RECEIPT DATE: 6/22/17 **ONSITE SEWAGE DISPOSAL SYSTEM**

PROPERTY ADDRESS: 8589 Reservoir Road

SUBDIVISION: Munro Property LOT: 2 TAX ID: _____

ONSITE SEWAGE DISPOSAL SYSTEM DESIGN PLAN
MUNRO SUBDIVISION-LOT 2
 8589 RESERVOIR RD. FULTON, MD 20759

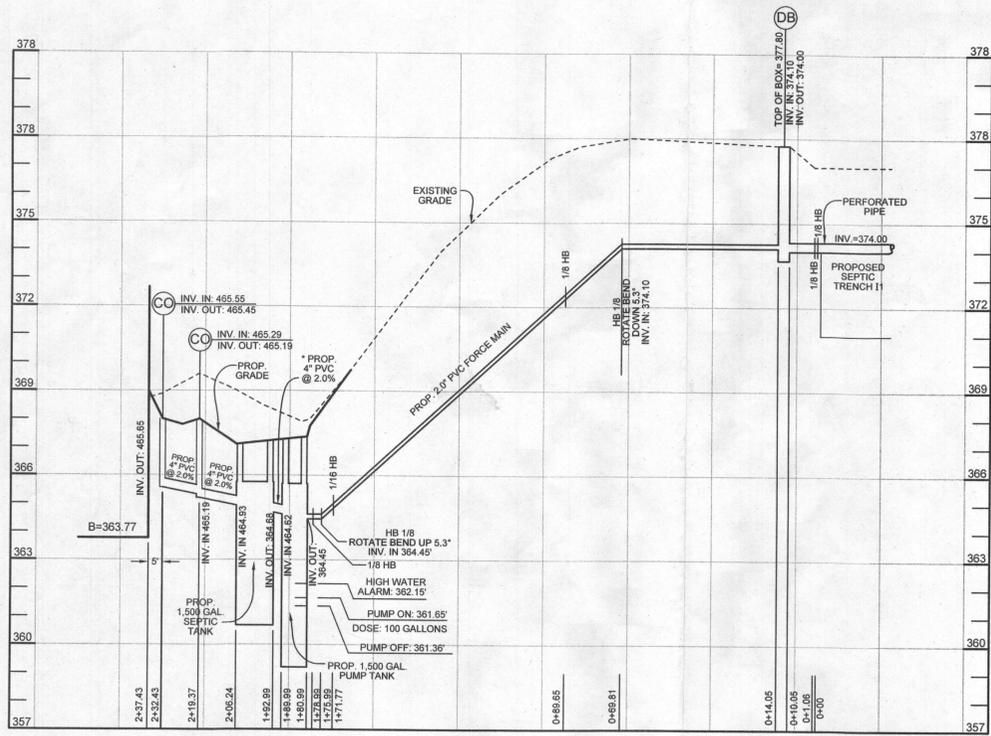
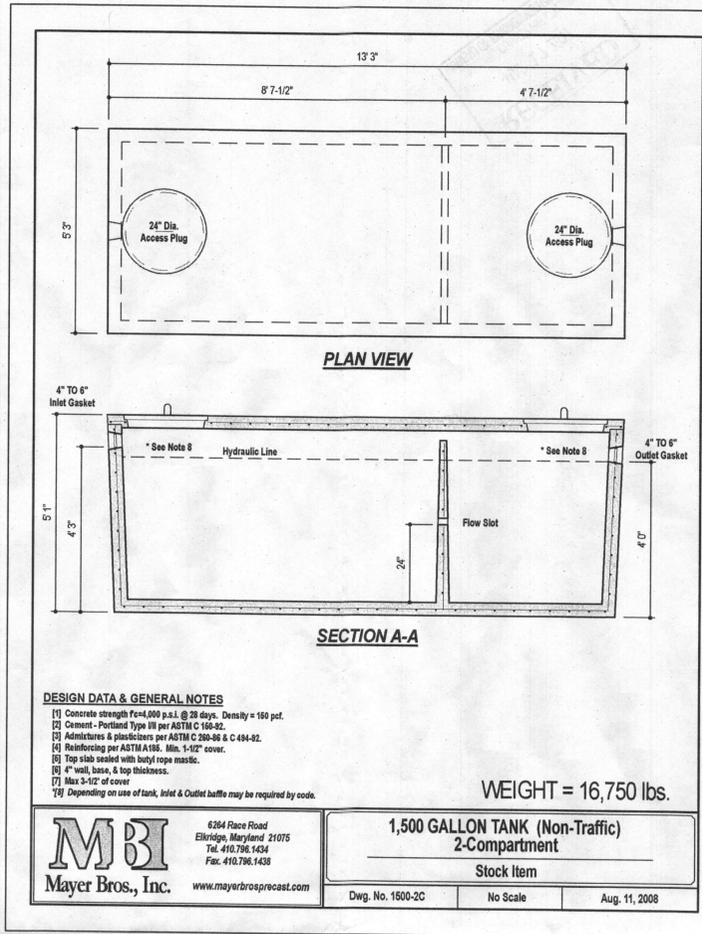
- 1.) The internal wall of the proposed tank does not contain a slot of minimum height of 2 inches and extend 4 feet in length per Howard County Code.
- 2.) All drywells must be at least 25 feet from all septic system components (tank, trench, and sewage disposal area or SDA).
- 3.) Show well line on plan meeting 10 foot setback from sewage disposal area. Any part of the line that isn't 10 feet from the sewage disposal area must be sleeved.
- 4.) Add note: Well line must be staked per approved OSDS plan prior to installation.
- 5.) Add dose and pump runtime to plan. Dose is no less than 1/6th the design flow or volume of water in FM.
- 6.) Show design head calculations
- 7.) Show cul-de-sac 10 feet from SDA

1. Please find the updated proposed tank with a slot that meets Howard County Code minimum standards.
2. Please note the house type has been revised. The bedroom count remains 4. The onsite sewage disposal system components have been relocated to meet minimum cover and setback requirements. The drywells have been moved and are 25' away from the system components, specifically the SDA and tanks. Please also note the revised calculations attached.
3. The well line has been shown on the plan. There is no need to sleeve the pipe.
4. Please see note 6 under Septic System Notes.
5. Please see note 7 under Septic System Notes that states dose and pump run time.
6. Please see note 8 under Septic System Notes for head calculations.
7. A dimension has been added at the T-turn around. There is not place where the distance from the SDA is less than 10'.

**1500 Gallon Pump Tank & Pump
Single Compartment**

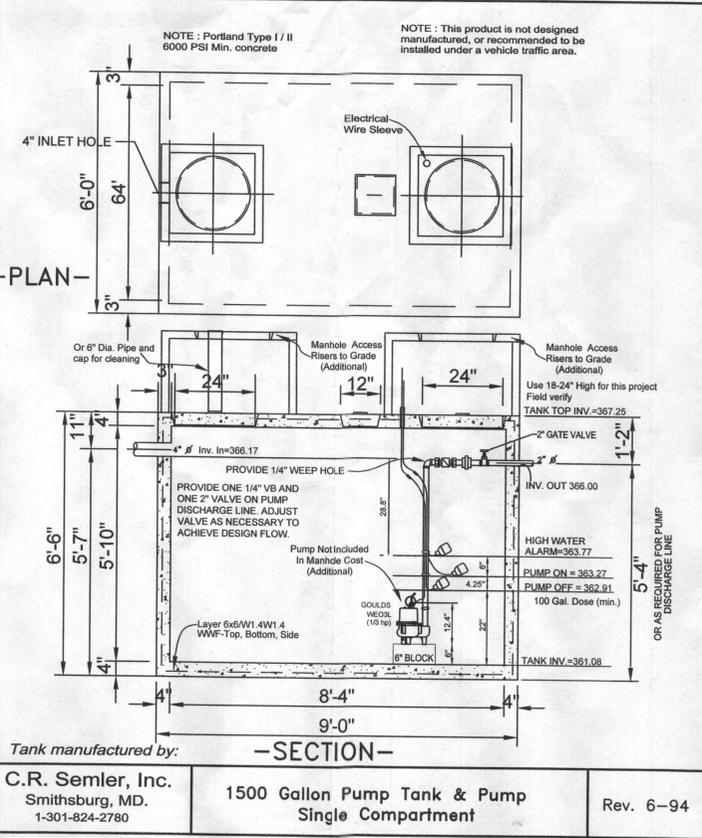
The new floor plan shows 5 bedrooms (including "Den" in basement) which exceeds the capacity of the Onsite Sewage Disposal System (OSDS) specifications. Please revise the OSDS Plan or floor plan to match
